Brisbane Central Business District Bicycle User Group

Bicycle Awareness Zones (BAZ) Standard Drawing BSD 5102

Section 6.5-1 Bicycle Awareness Zones, of the TRUM manual was updated in April 2015 and BSD-5102 is inconsistent with it. BSD-5102 Figure 4 “Bicycle Awareness Zones where Edgelines are Required” is as follows:

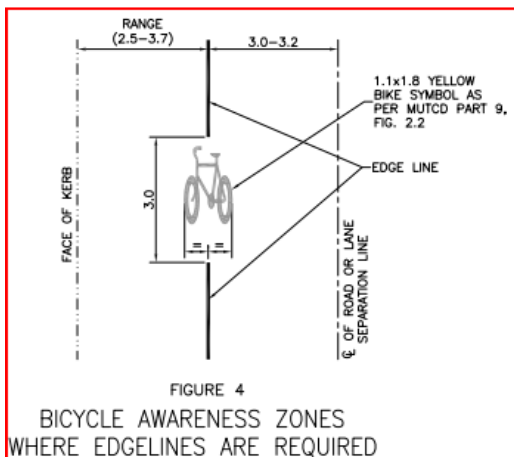
TRUM recognises this usage as inappropriate and specifically cites a location in Brisbane to illustrate:

CBD BUG requests you now ensure BSD-5102 is amended to reflect Figure 4.1.1 of TRUM as it clearly positions people riding bicycles in a safer location on the carriageway with respect to the "door zone".

TRUM Figure 4.1.1-A provides dimensions for Bicycle Awareness Zones on a two-laned general traffic road with parallel parking that are significantly safer.
